**MODIFICATION INSTRUCTION**

Bulletin Nbr: 291-2211 utg. 3

**Replacement of check valve and banjo screw to remedy blue smoke****Emissions-related campaign 10719**

Saab 9-5 with 4 cylinder engine M98-M00 up to and including VIN Y3041906

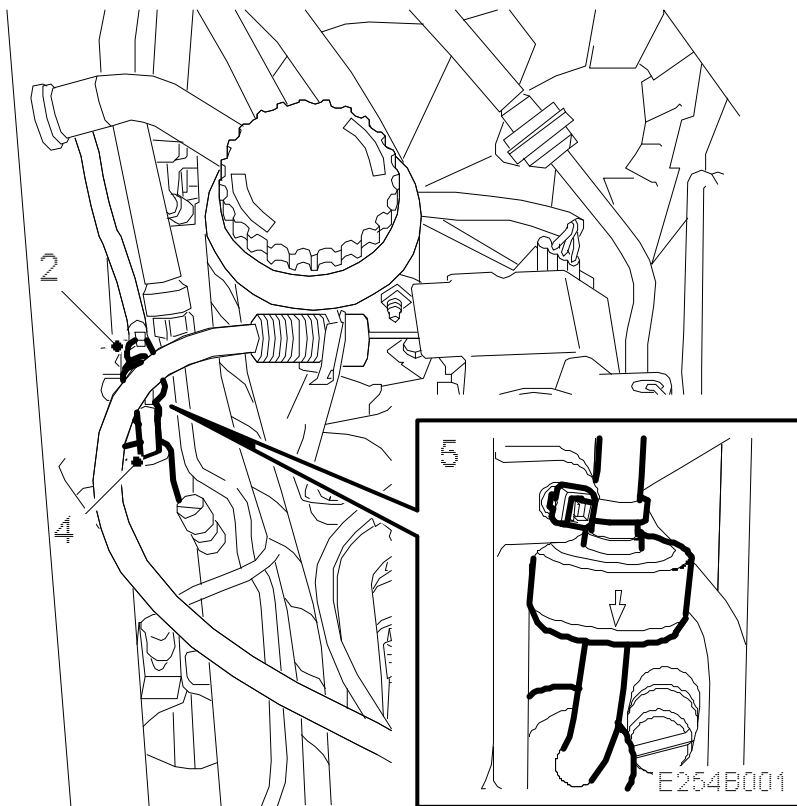
2. Cut off the cable tie securing the check valve to the camshaft cover.
3. Pull the check valve vacuum hose off the camshaft cover and the throttle body.
4. Transfer the insulation hose from the old hose to the new.
5. Connect the new hose to the throttle body.

The check valve must be turned so that the flow is directed away from the camshaft cover towards the throttle body, see the arrow on the check valve.

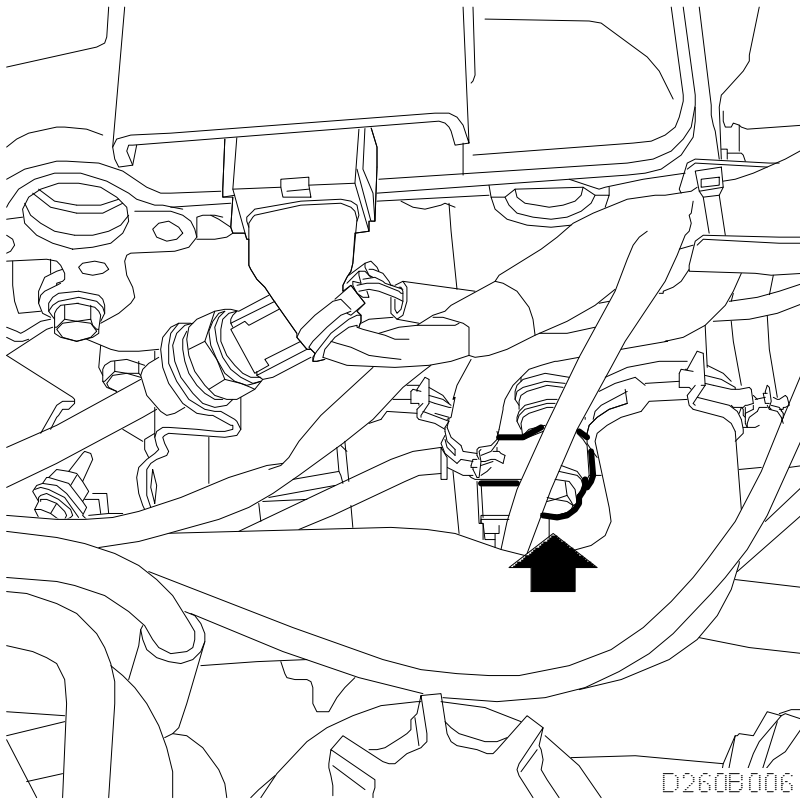
Using a fixed spanner to hold the coolant pipe nipple in place on the cylinder head, detach the coolant pipe from the cylinder head, see illustration, and the pressure sensor mounting.

19. Check that the coolant pipe nipple on the cylinder head is tightened, and fit the coolant pipe with a new banjo screw and new gaskets in the cylinder head, see illustration. Fasten the pipe to the pressure sensor mounting.

Banjo screw 51 25 406 must not be fitted anywhere else on the cooling system other than on the cylinder head connection.

**Nipple in cylinder head 35 Nm (25.8 lbf ft)**

**Banjo screw, cylinder head 25 Nm (18.4 lbf ft)**
